Typical details: where CAD and Revit draw the same detail differently

55 of the 190 CAD typical details have a Revit version in your templates that is drawn differently.

Compared by eye on 2026-10-23 from Nelson's CAD blocks and the Concrete Tower R24 / Steel R24 / Container R23 templates.

CAD: KOR-D501-DET 18 - PENTHOUSE SPIRAL STEEL STAIR PLAN

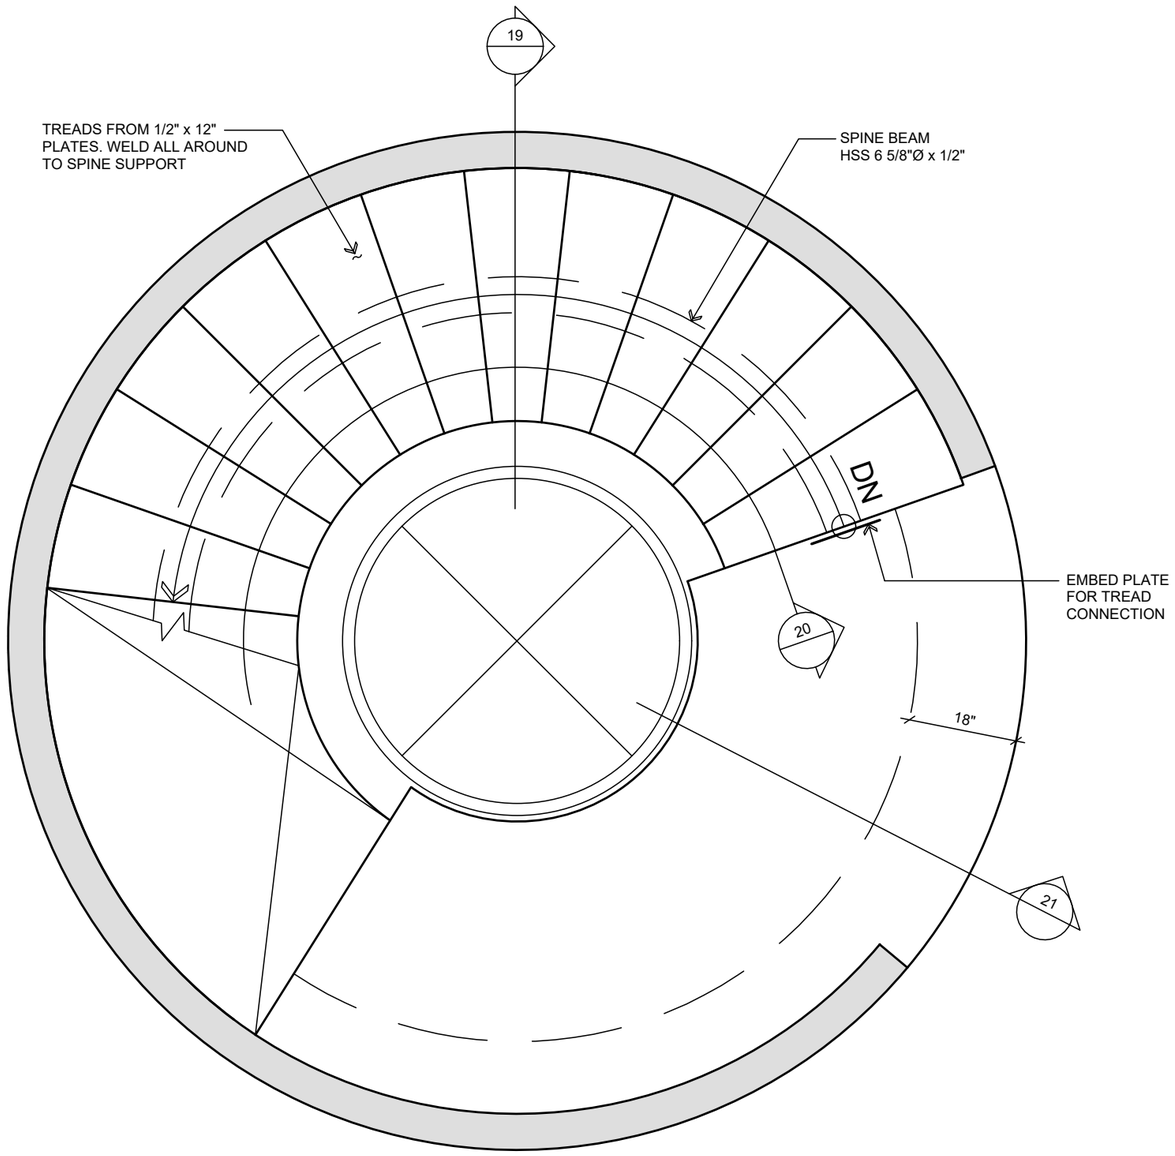
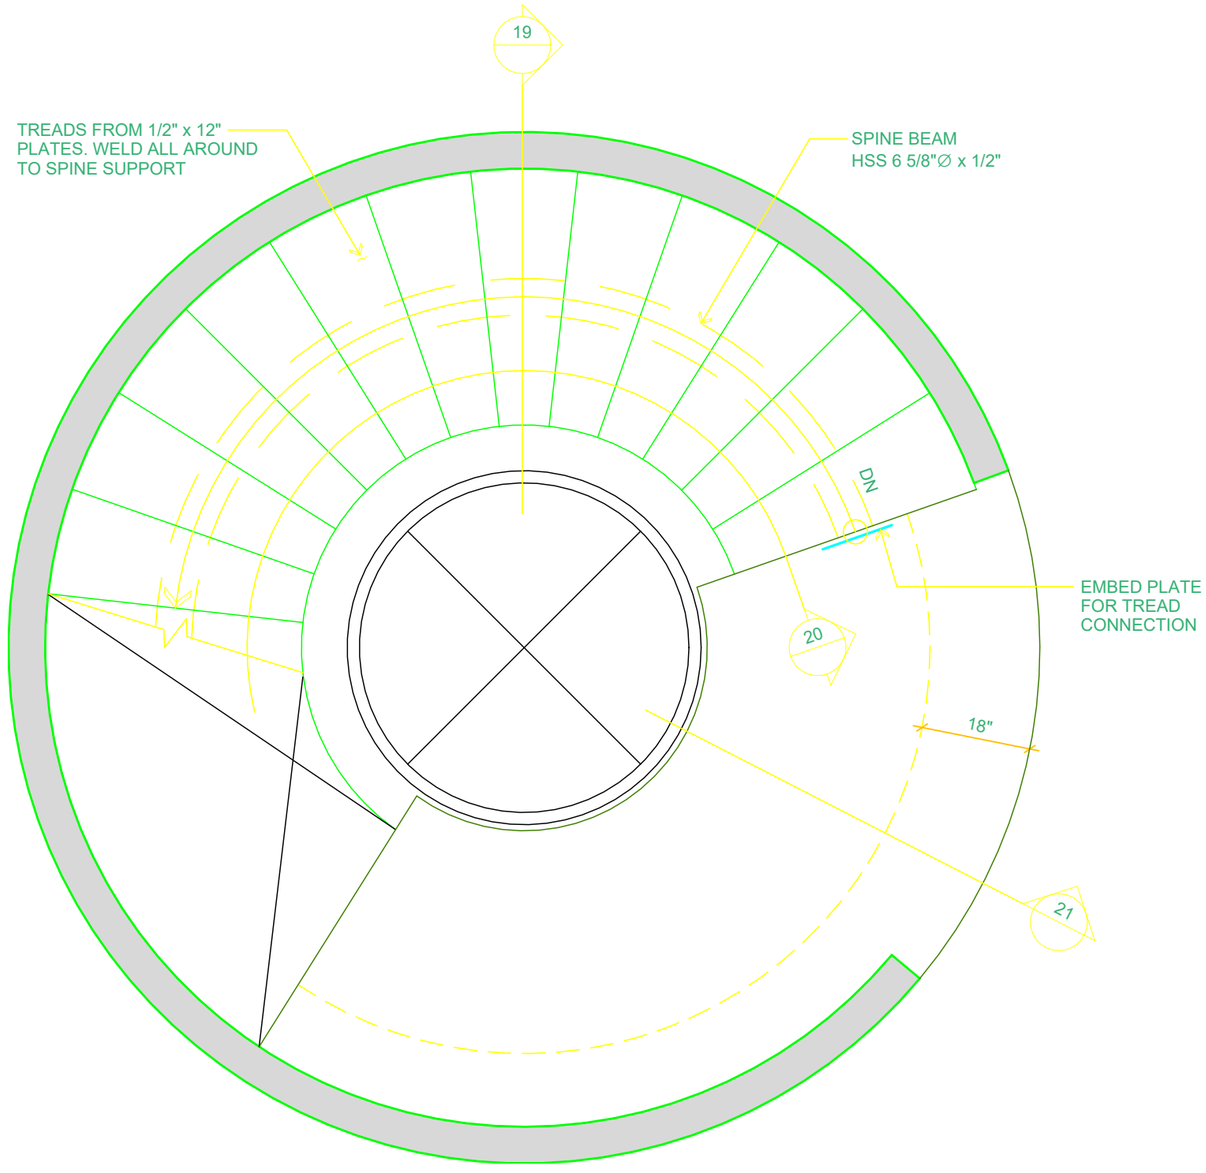
What differs: Same spiral stair plan content (treads, spine beam, embed plates) but CAD plan is drawn elliptical, Revit circular.

Revit: D5.02_10_TYPICAL ON GRADE SLAB THICKENING (Typical Details - Container_R23 (Need_MET & IMP).rvt; on D5.02 Series 5 Miscellan)

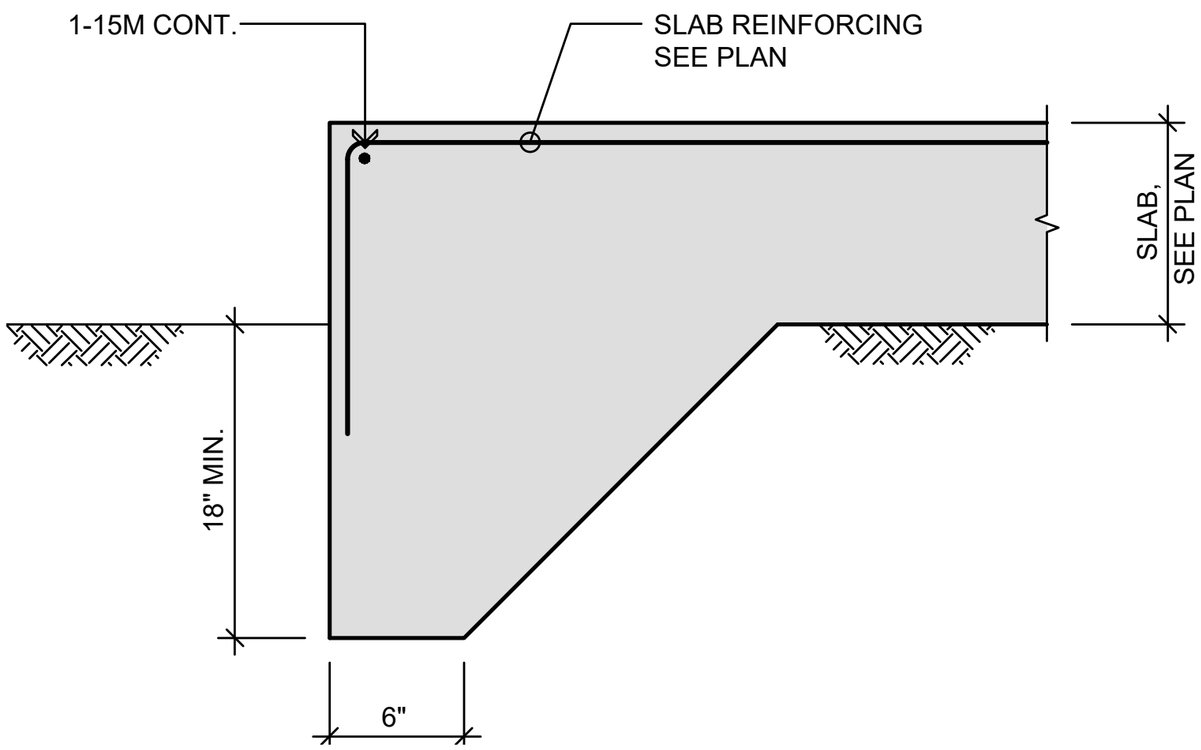
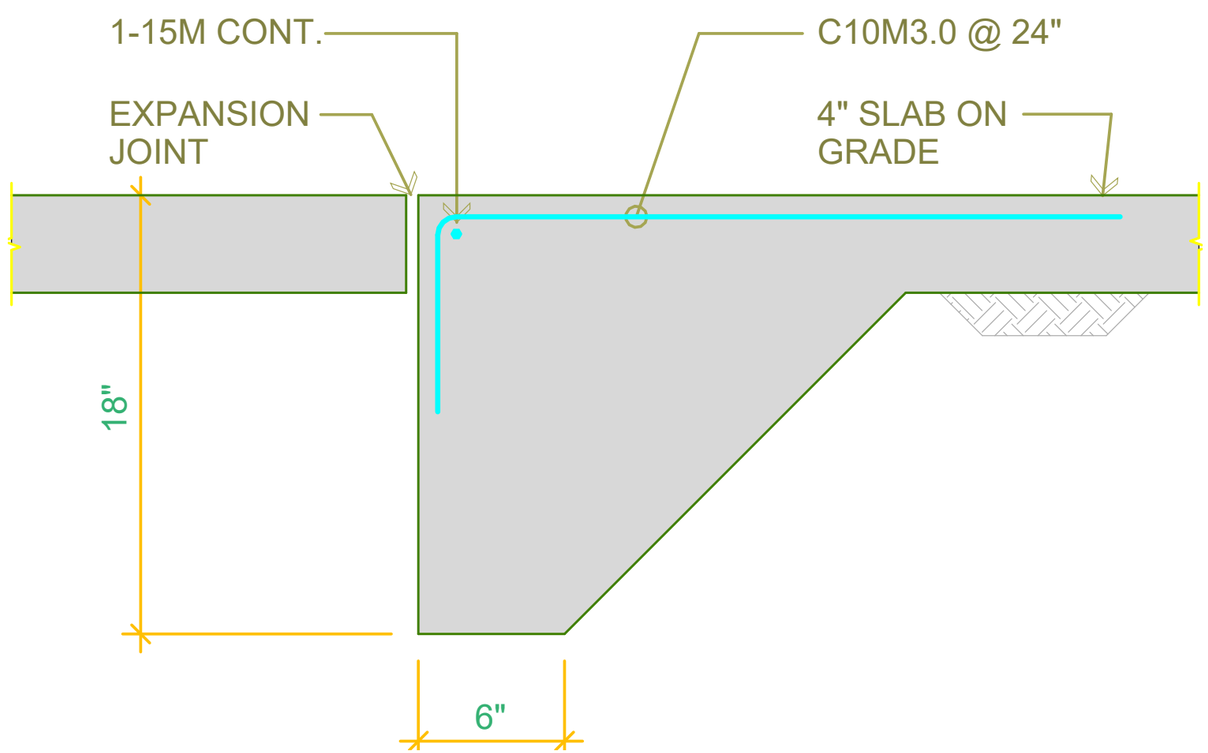
What differs: Thickened slab edge like 'D5.02_10_TYPICAL ON GRADE SLAB THICKENING' but no expansion joint/adjacent slab and different callouts.

CAD: KOR-D502-DET 12 - TYPICAL BUILT-UP SLAB UNO

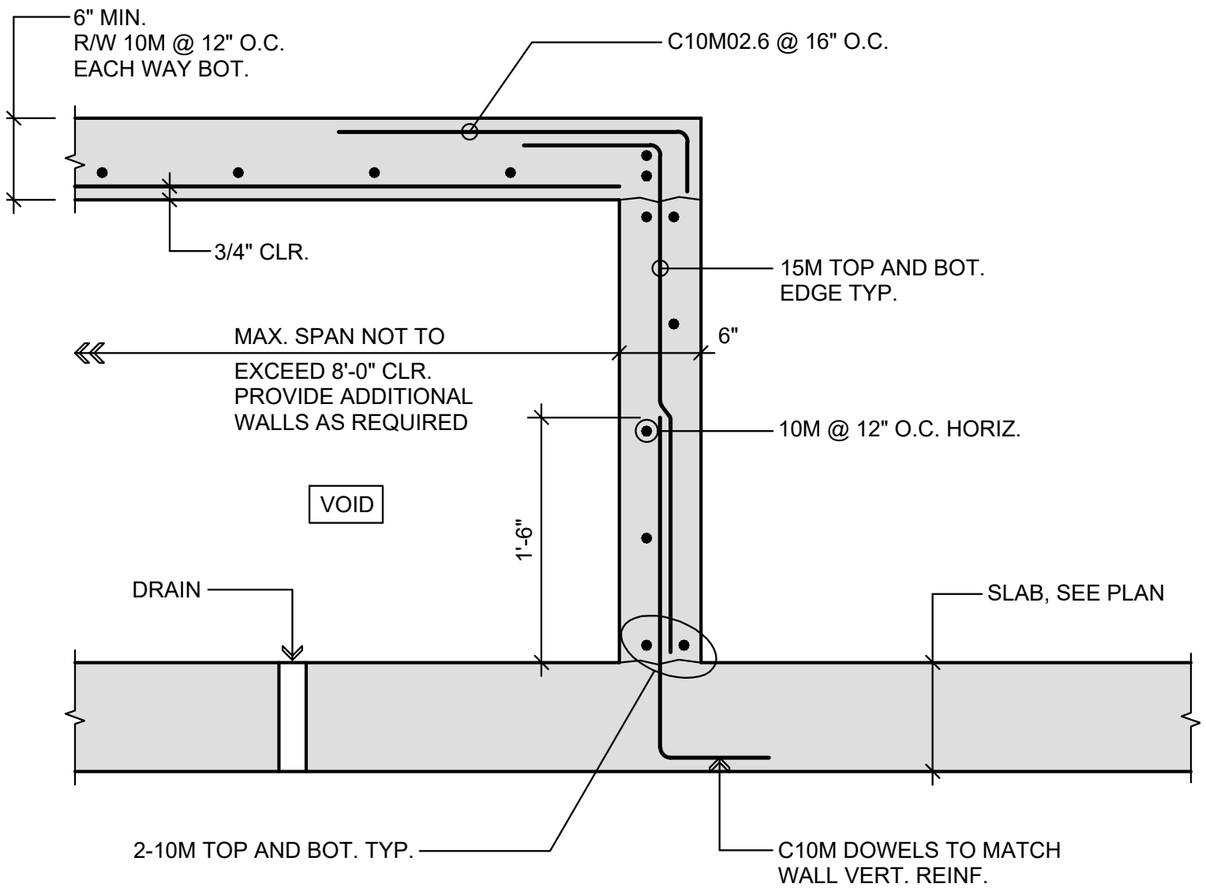
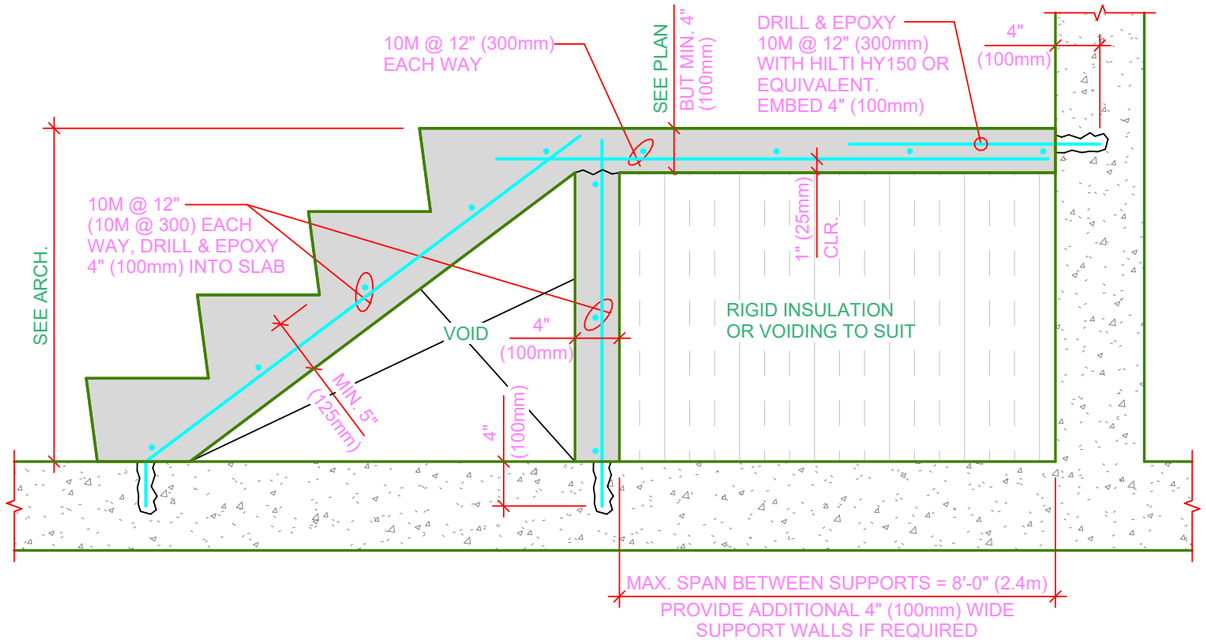
What differs: Both built-up slabs with void and max 8ft span support walls, but CAD is slab on walls with drain, Revit is stepped fill with insulation.

CAD: KOR-D502-DET 18 - POST-CAST CONCRETE BRICK LEDGER

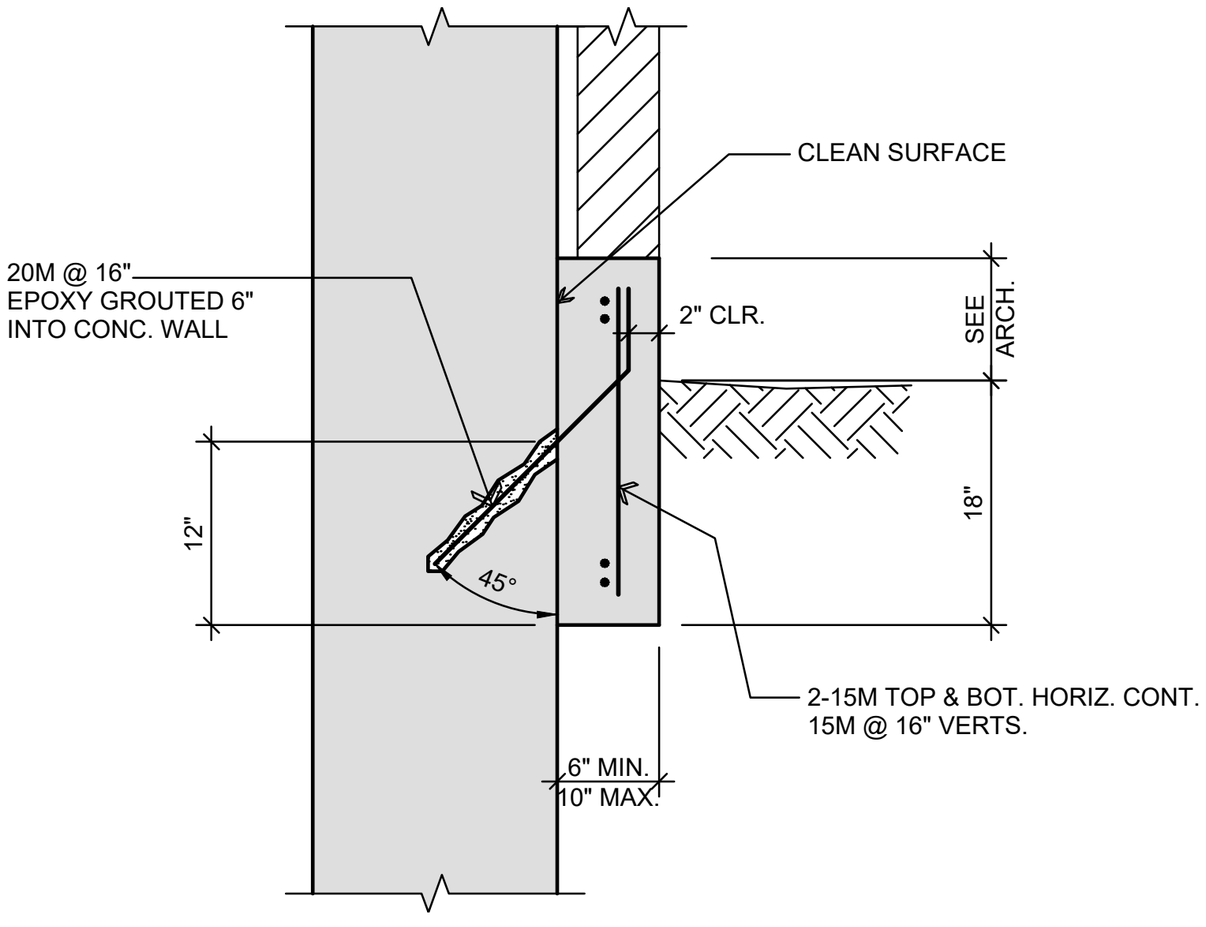
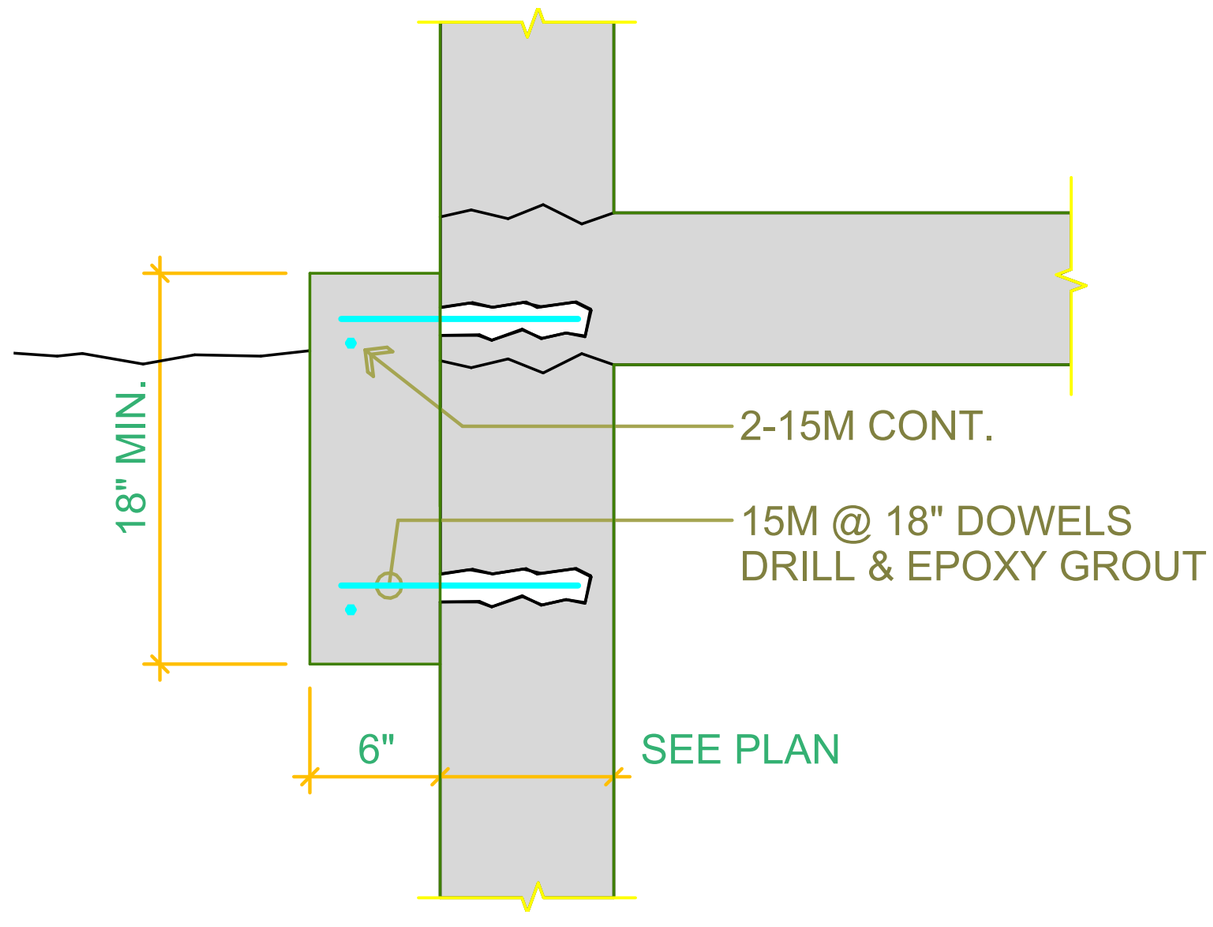
What differs: Both brick ledgers, but CAD is a post-cast ledger with 45 deg epoxied bars, Revit a cast ledger with horizontal dowels.

CAD: KOR-D502-DET 28 - TYPICAL COLUMN CAPITAL

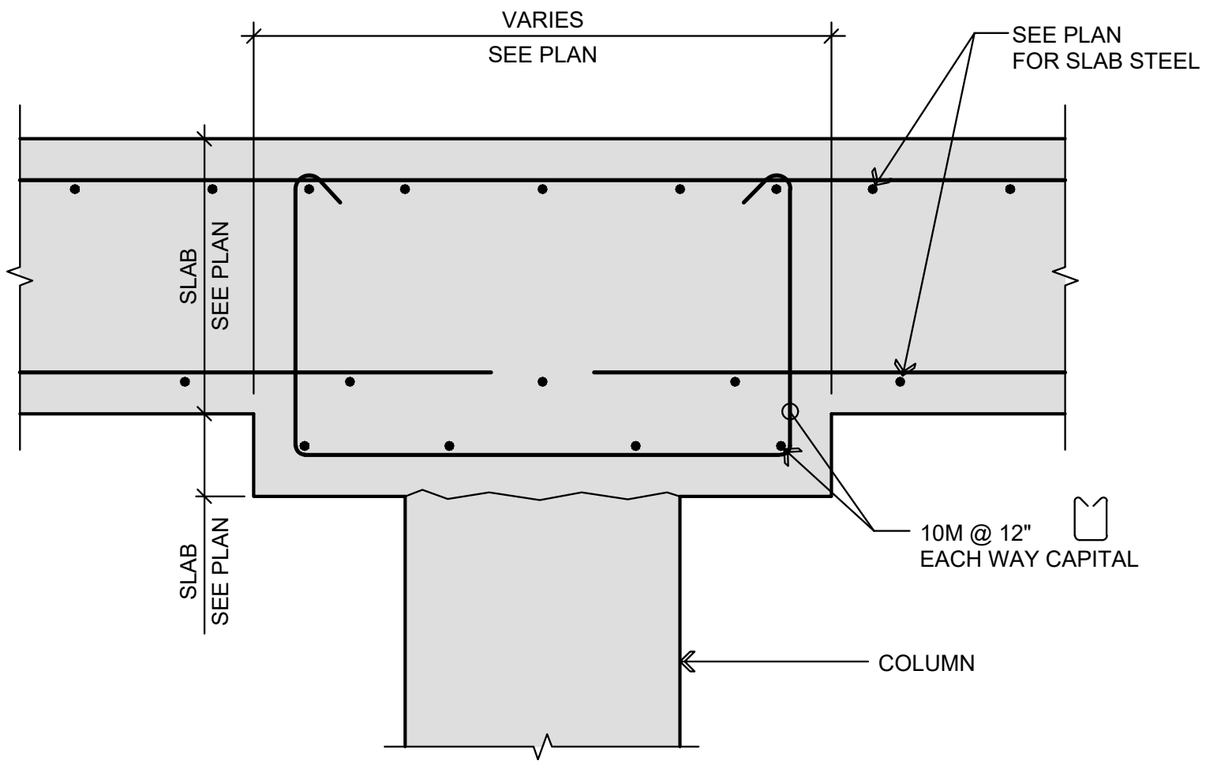
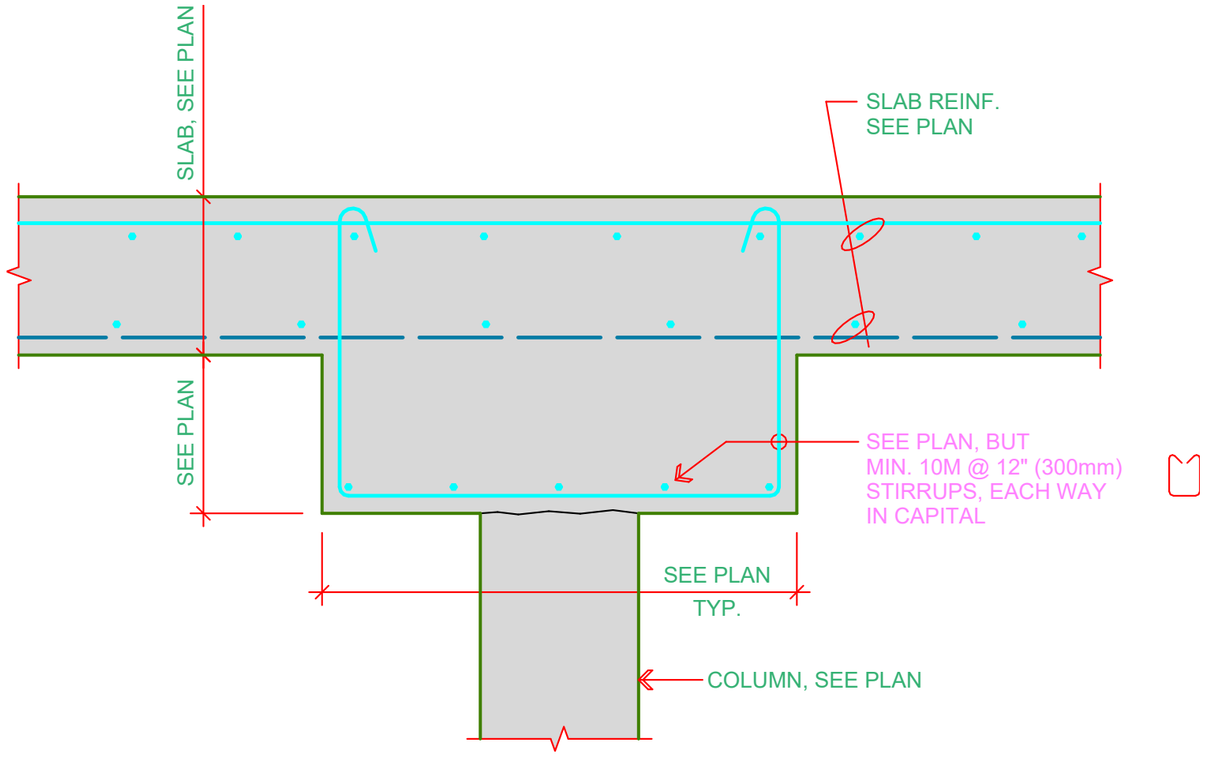
What differs: Column capital but CAD capital is wider with a different bar arrangement and no hooked top bars.
